DATE: June 15, 2016

AGENDA ITEM # 2

TO: Design Review Commission
FROM: Sean K. Gallegos, Assistant Planner
SUBJECT: 16-SC-08 – 581 University Avenue

Tree #2 has multiple co-dominant leaders, clustered 8-10' above grade

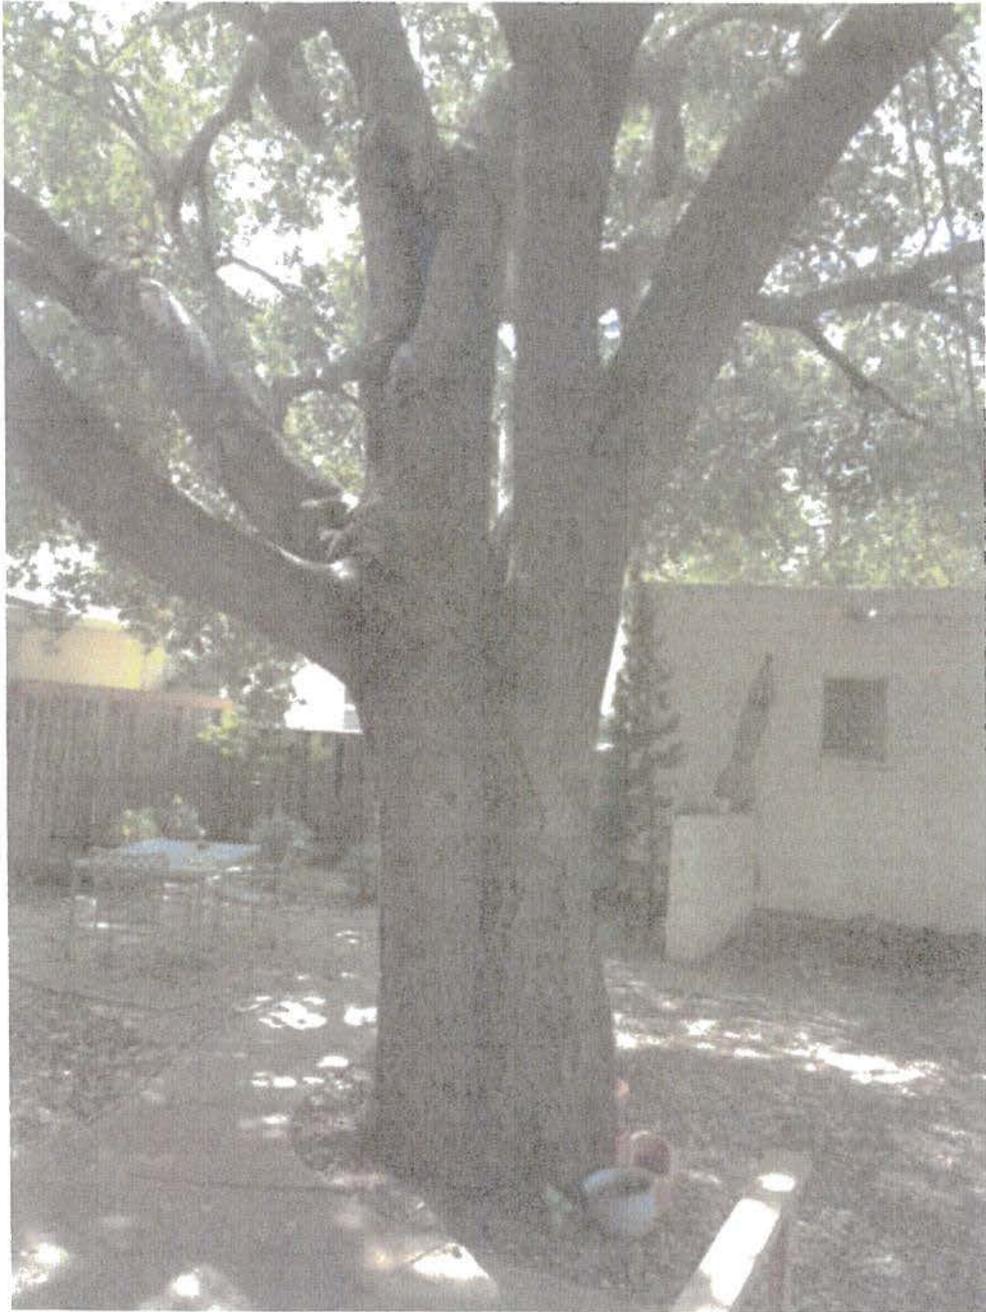
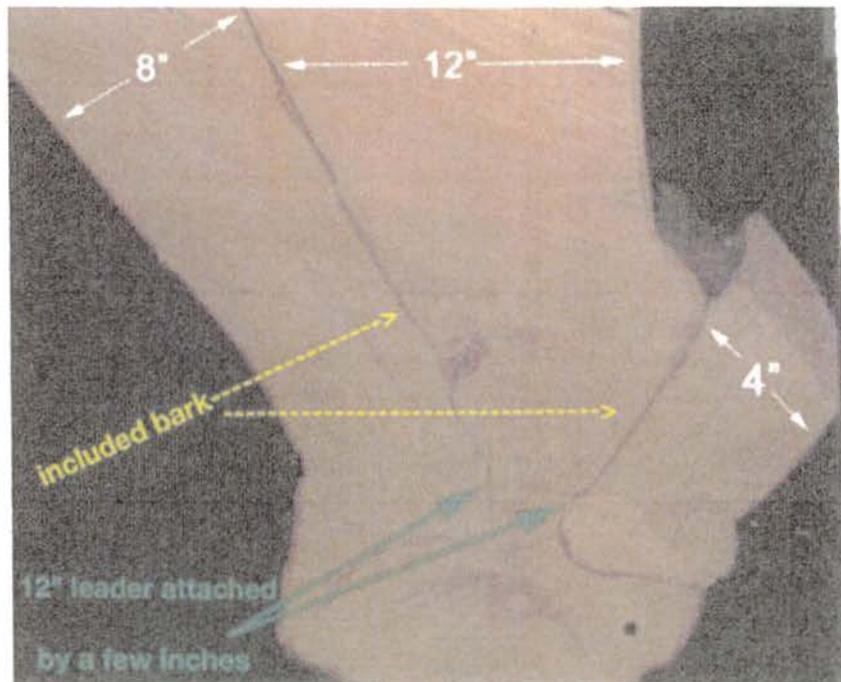
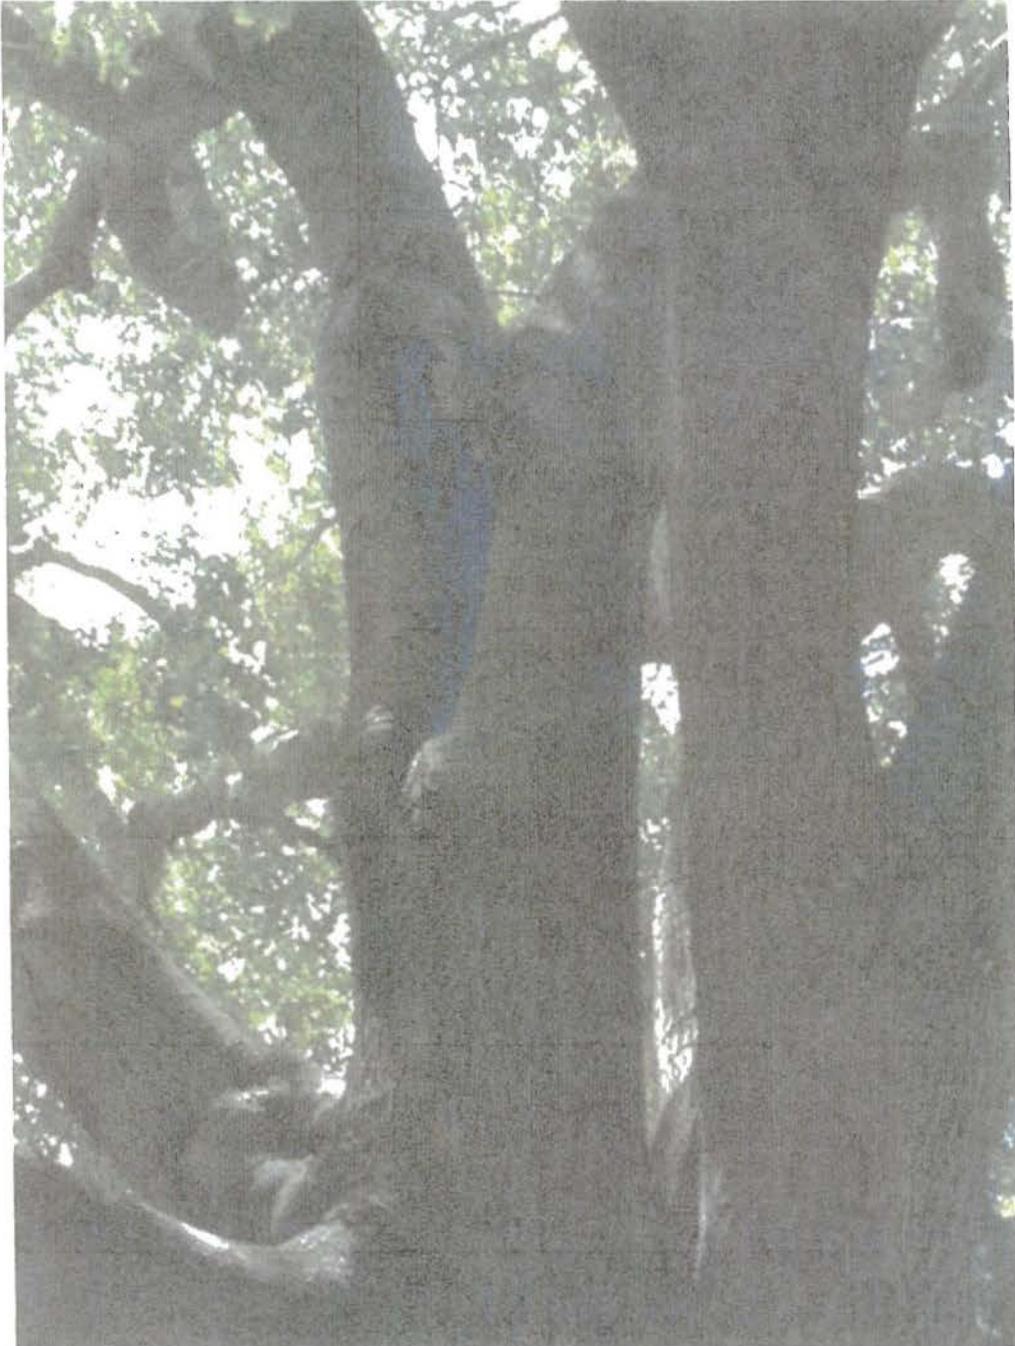
Section 11.08.90 of the Los Altos Municipal Code lays out the criteria that a protected tree must meet to be removed. This tree meets the following criteria:

1. This tree or its major leaders could fail at any time due to poorly attached leaders and a large hollow. It is in close proximity to the home and garage on site and overhangs virtually all of the rear yard.
3. The lot is flat. The tree's removal will have no effect on erosion, soil retention or water drainage in the area.
7. There are no reasonable and feasible ways to ensure the safety of this tree.

The leaders are poorly attached with included bark. As these narrowly attached leaders grow, they push themselves away from each other and split apart.

The tree has a large hollow at 12', where a third, equally dominant, poorly attached leader split from the other leaders. The hole is about 3' long and is the heartwood (dense, non-living xylem that gives trees structural strength and stability) has rotted out of the center. The remaining outer portions of these conjoined leaders are structurally weak without the heartwood and could split from each other or break from the lower tree at any time. Failure of this portion of the tree would likely cause more leaders to fail below it as it fell.

Tree Protection Plan Diagram - 581 University Ave, Los Altos CA

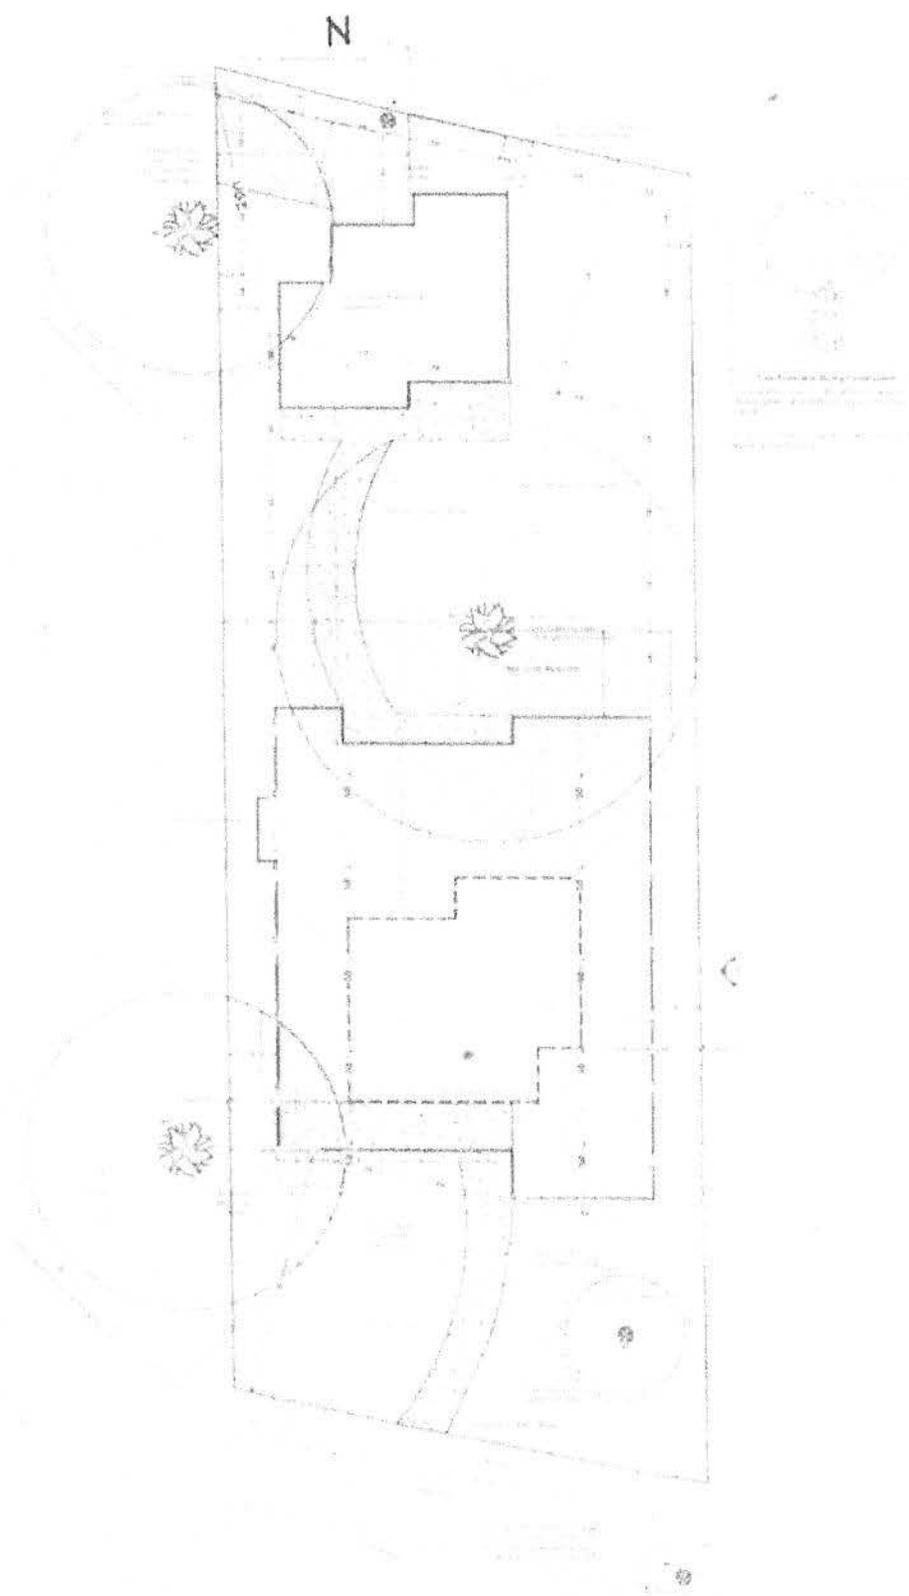
Tree #4: coast redwood, 33" DBH, 24'w X 95'h. Health =B, Structure= A, TPZ = drip line or minimum 16.5' in all directions from the trunk (on the project site). Protective fencing must be placed where possible given buildings and other impediments. When the project has commenced to the point that the fencing needs to be moved back in order to provide work area and construction of approved intrusions into the TPZ, the project arborist must be on-site to supervise the moving and re-anchoring of the tree protection fencing. Any pruning needed for construction clearance must be done by a company with a certified arborist on staff.

This tree is located about 30" from the property line on the adjacent property and overhangs the subject property by about 12'. The nearest edge of the basement/shoring excavation for the home at 581 University Avenue is 7'6" from the trunk of this tree. This excavation will remove approximately 6% of the tree's roots and will not significantly impact the tree's health. Roots larger than 2" diameter must be cut off cleanly at the edge of the excavation, covered with burlap and kept moist until the excavation is backfilled. Fencing, mulching and irrigation of the tree as recommended under General Tree Protection Plan should be followed.

Tree #5: coast redwood, 3" DBH, 22'w X 100'h. Health =B, Structure= A, TPZ = drip line or minimum 15' in all directions from the trunk (on the project site). Protective fencing must be placed where possible given buildings and other impediments. When the project has commenced to the point that the fencing needs to be moved back in order to provide work area and construction of approved intrusions into the TPZ, the project arborist must be on-site to supervise the moving and re-anchoring of the tree protection fencing. Any pruning needed for construction clearance must be done by a company with a certified arborist on staff.

Protective fencing must protect a sufficient portion of the root zone to be effective. In most cases, it would be essential to locate the fencing a minimum radius distance of 6 times the trunk diameter in all directions from the trunk. There are areas where we will amend this distance based upon proposed construction. In my experience, the protective fencing must:

- a. Consist of chain link fencing and having a minimum height of 6 feet.
- b. Be mounted on steel posts driven approximately 2 feet into the soil.
- c. Fencing posts must be located a maximum of 10 feet on center.
- d. Protective fencing must be installed prior to the arrival of materials, vehicles, or equipment.
- e. Protective fencing must not be moved, even temporarily, and must remain in place until all construction is completed, unless approved by a certified arborist.
- f. Tree Protection Signage shall be mounted to all individual tree protection fences.
